**FINAL DRAINAGE REPORT  
FOR  
ESTATES AT CATHEDRAL PINES,  
EL PASO COUNTY, COLORADO**

PCD File No. **SF23-XXX**

**EGP232**

September 2023

PROPOSED DRAINAGE MAP  
ESTATES AT CATHEDRAL PINES  
JOB NO. 25260.00  
09/15/2023  
SHEET 1 OF 1

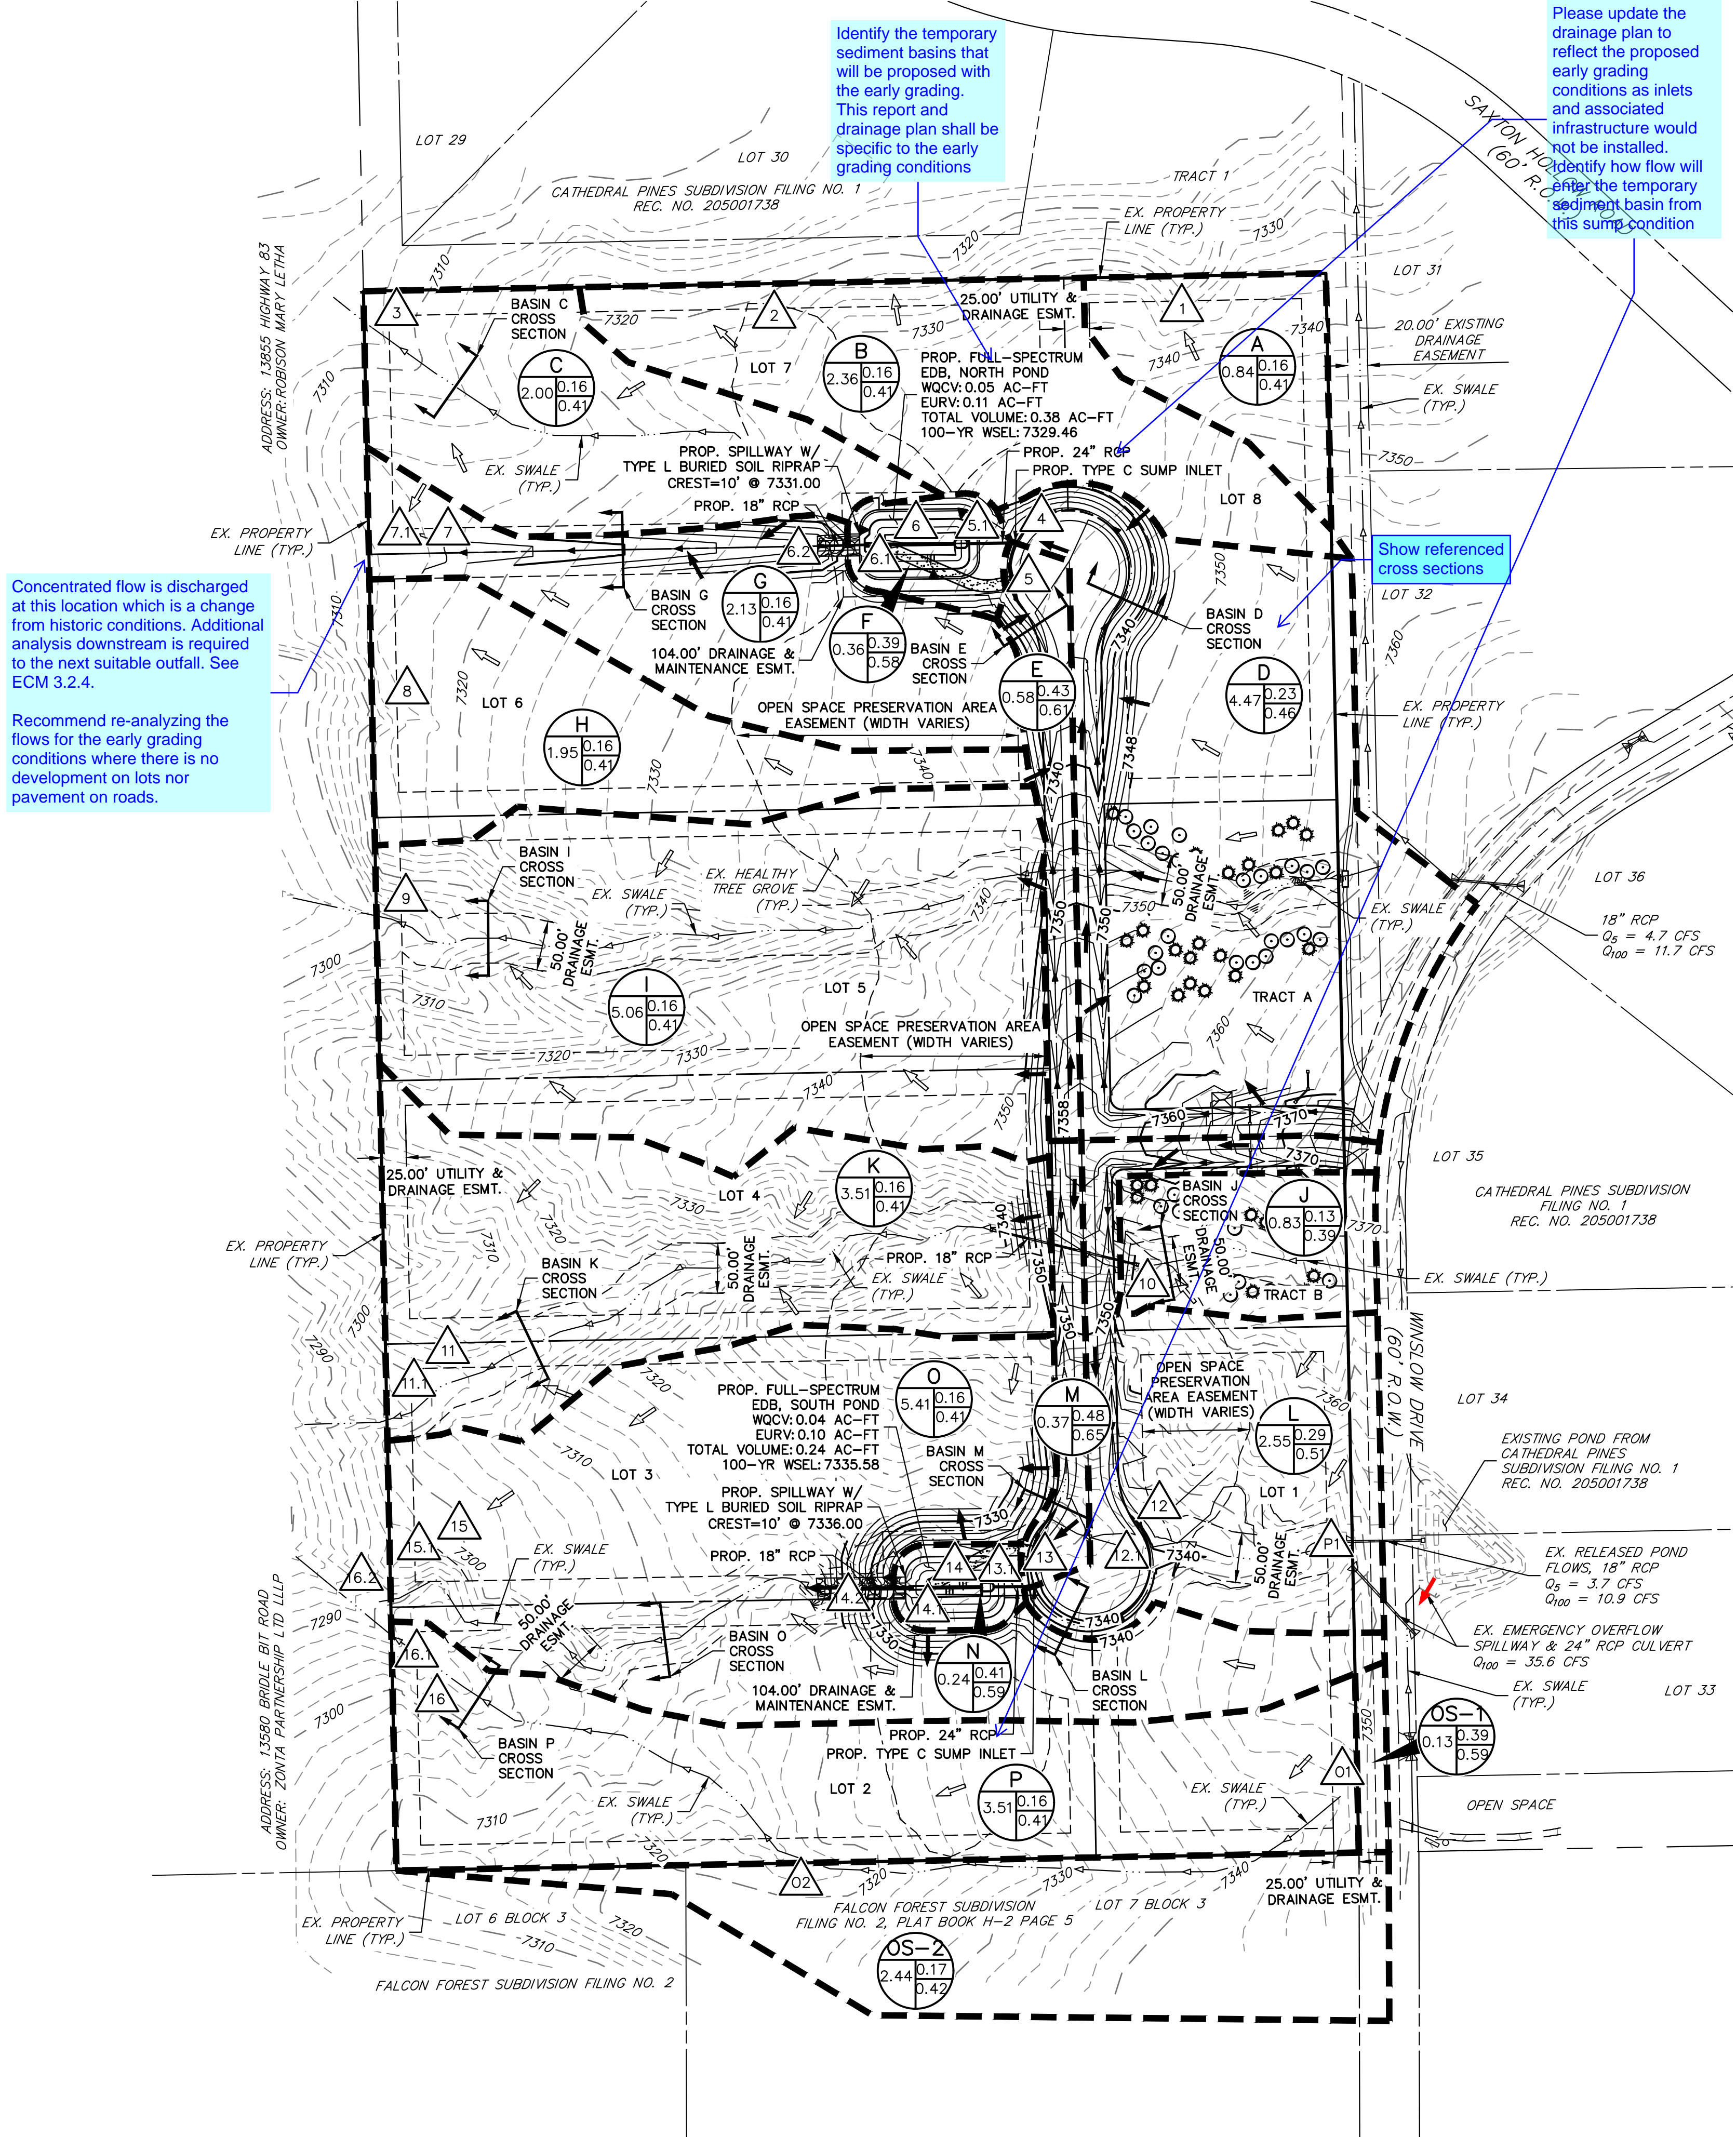
Show referenced cross sections
